MONITORING YEAR 4 ANNUAL REPORT

CROOKED CREEK #2 RESTORATION PROJECT

RE: Crooked Creek II Mitigation Site -Year 4 Monitoring Report
Final Submittal for DMS
DMS ID 94687
DEQ Contract Number D09126S
Yadkin Pee-Dee River Basin – CU# 03040105; Union County, NC

Wildlands Engineering, Inc. (Wildlands) has reviewed the Division of Mitigation Services (DMS) comments and observations from the Crooked Creek II Mitigation Site Draft Year 4 Monitoring Report. The following are Wildlands responses to your comments and observations from the report noted in italics lettering.

Recorded In-stream Flow Events
Crooked Creek #2 Restoration Project
DMS Project No. 94687
Monitoring Year 4 - 2019

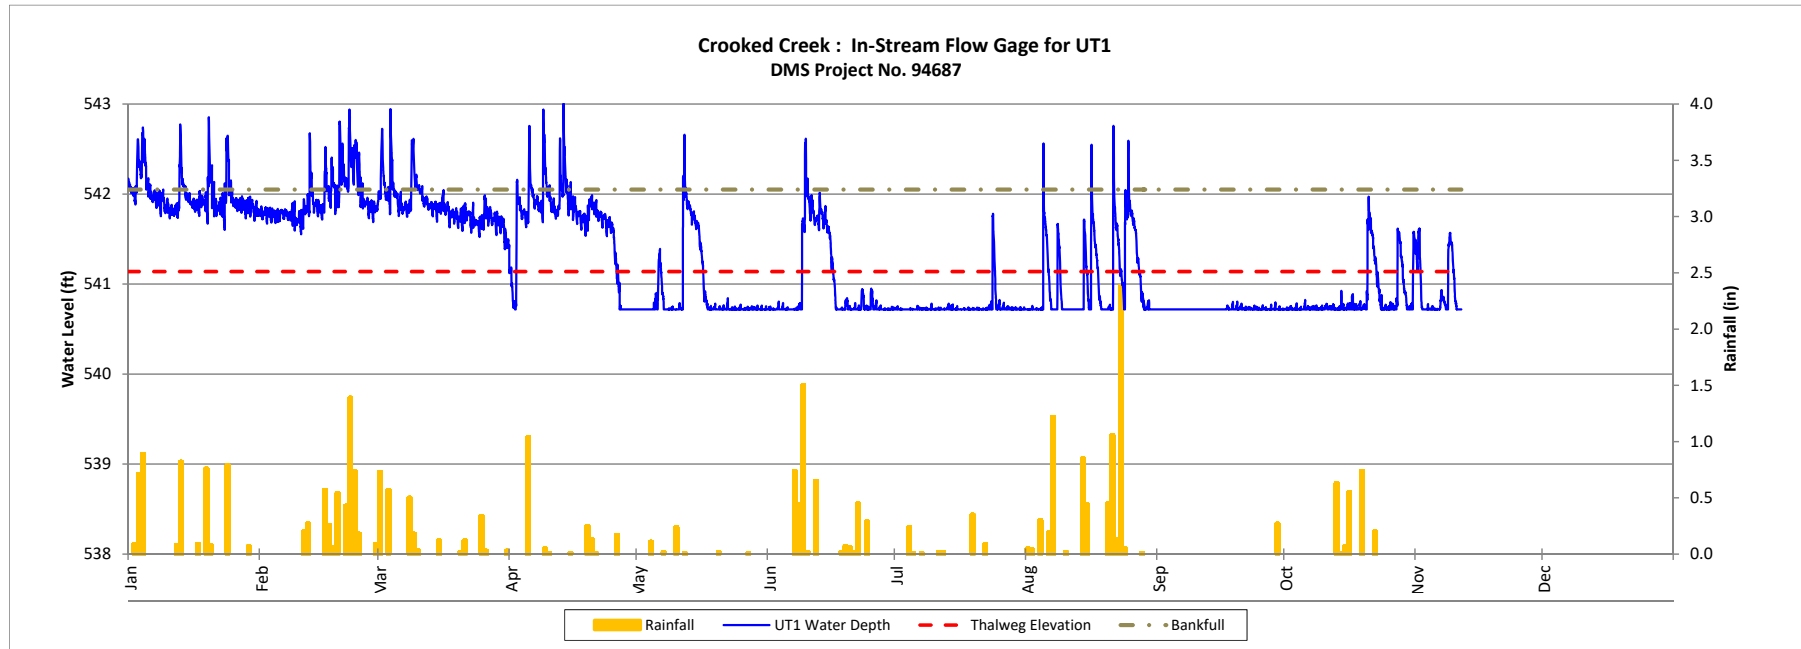
DMS Comment; Continuous flow gauge graph for UT1 (reflecting 116 consecutive days of flow described in section 1.2.5) is missing from Appendix 5.

Wildlands Response; Wildlands has updated Appendix 5 to include flow gage for UT1.
